VERIFICATIONREPORT FOR THE VCS PROJECT:

Beijing Guanting Wind Power Project Phase II and Phase II addition

Document Prepared By: China Quality Certification Center (CQC)

Report No: CDM-VER-2011-0051(verification)

Figure 4-1. The connection structure and the meter locations

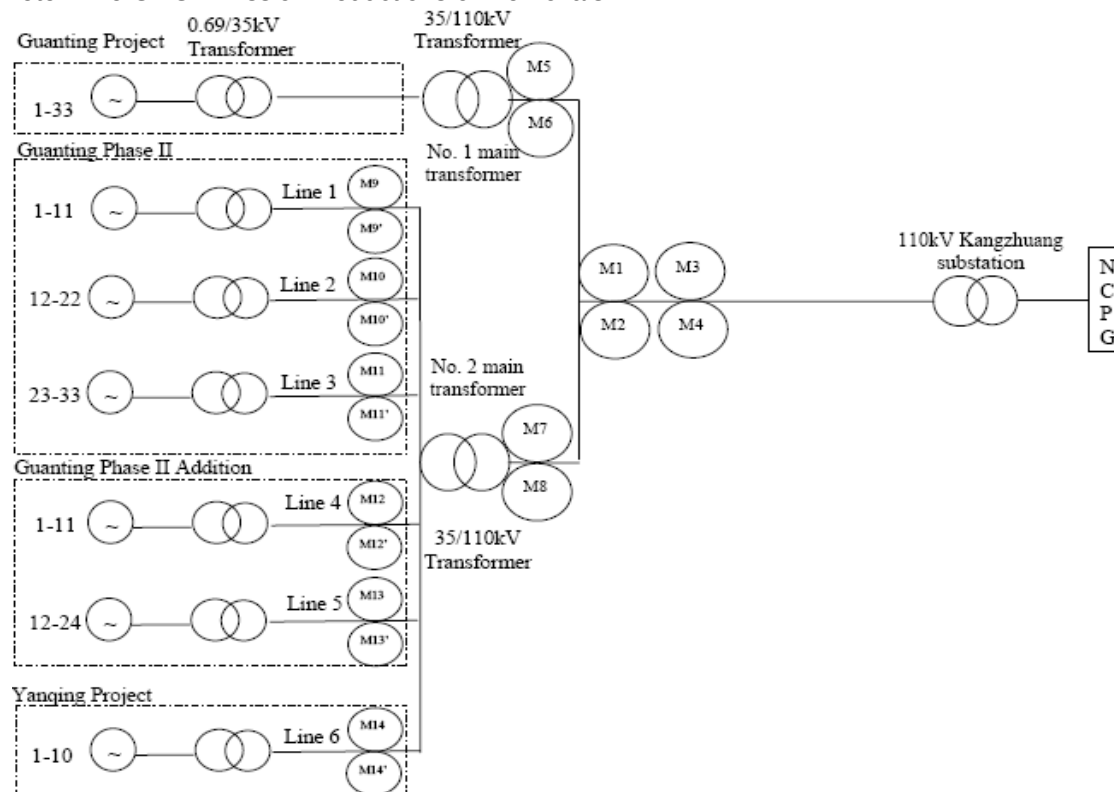
But the installation of M9/M9'-M13/M13' is later than 23/08/2010, and the readings from

M9/M9'-M13/M13' are inaccurate before 21/12/2010. So it is impossible to use the monitoring records of M9/M9'-M13/M13' to calculate $EG_{PJtoGrid,y}$ during 23/08/2010 to 21/12/2010. Although it is possible to use the monitoring records of M9/M9'-M13/M13' to calculate $EG_{PJtoGrid,y}$ after 21/12/2010. PP chooses a conservative deviation to calculate $EG_{PJtoGrid,y}$ from equation (6) above to equation (7) during the rest monitoring period from 23/08/2010 to 27/02/2011 for simplification as follows:

Although PP claims that equation (7) is conservative comparing to equation (6) in $EG_{PJtoGrid,y}$ calculation in the MR version 01. The further clarification on this claim was not provided in the MR version 01. With respect to this issue, **CL01** was raised during this verification and successfully closed out by PP. (Detailed information about this CL please see table 3-3 above and the revised MR version 02.) As a result, CQC team confirms this deviation is conservative and acceptable. The monitoring result of $EG_{PJtoGrid,y}$ is presented as the following table:
